Subject: Docket Number 070-03098
Duke Cogema Stone & Webster
Mixed Oxide (MOX) Fuel Fabrication Facility
Response to Request for Additional Information – MFFF Criticality Validation
Report (DSER Open Item NCS-04)

Enclosure 1
Response to Request for Additional Information (MFFF Validation Report)
DSER Open Item On Nuclear Criticality Safety

Benchmark K-effectives for AOA(5)

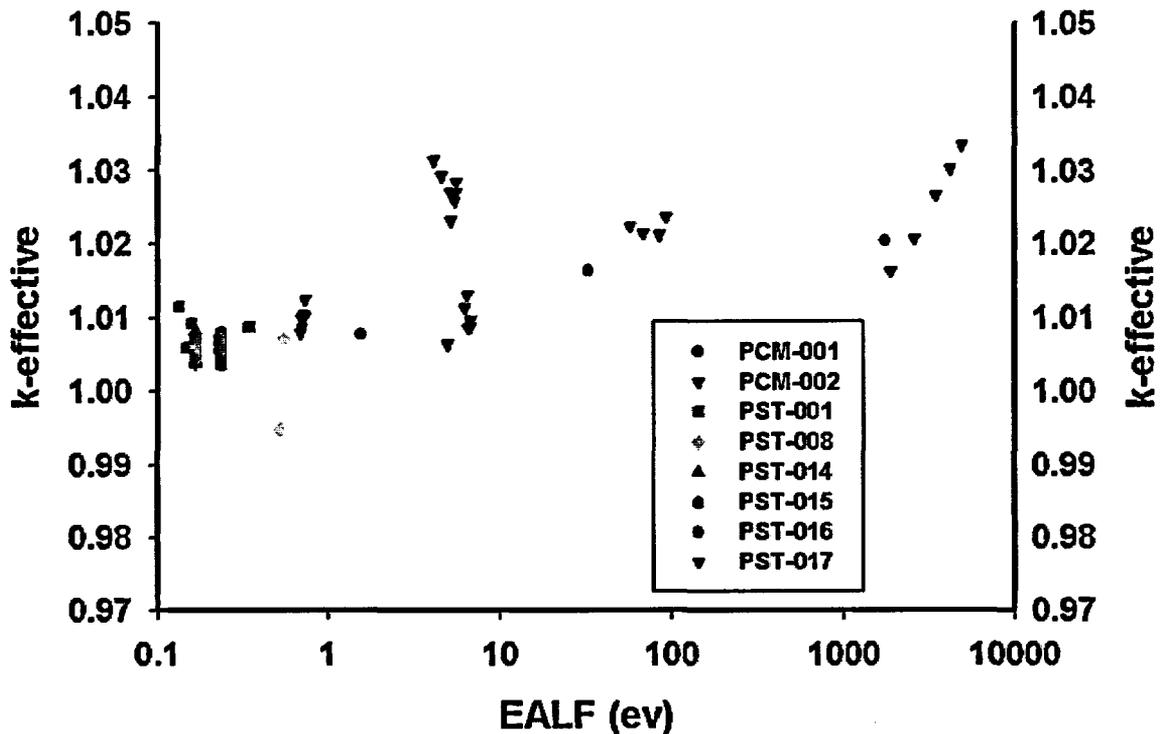
- Q** B. For Part III, show that a comparison of EALF values is sufficient to show a high degree of applicability between systems (i.e., that it accounts for all important nuclear effects that can influence the bias).
- R** In Part III, applications with Pu-nitrate, Pu-oxalate, and the PuO_2F_2 "Standard Salt" were compared based on EALF values because the only important differences for the three compounds from a nuclear consideration are the absorption and scattering cross-sections in nitrogen, carbon, and fluorine. The range of geometries, fissile material enrichments, reflectors, and other material constituents are typically the same for all three cases, and

molecular effects on cross-sections of $\text{Pu}(\text{NO}_3)_2$, $\text{Pu}(\text{C}_2\text{O}_4)$, and PuO_2F_2 are not significant. Since the absorption and scattering cross-sections vary somewhat with energy, however, EALF values represent a valid basis for comparison.

This consideration is evidenced in Tables 6.1 and 6.2 in Section 6.1.2 which show that the minimum USLs for the Group 1 and Group 2 benchmarks relative to the EALF, H/Pu, and ^{240}Pu content occur for the case of the EALF parameter. Also, the following figure gives a plot of all of the benchmark data in Part III, showing that the 119 benchmark experiments covering an extensive range of EALF with no clusters of negative trend benchmarks that could indicate important alternate effects.
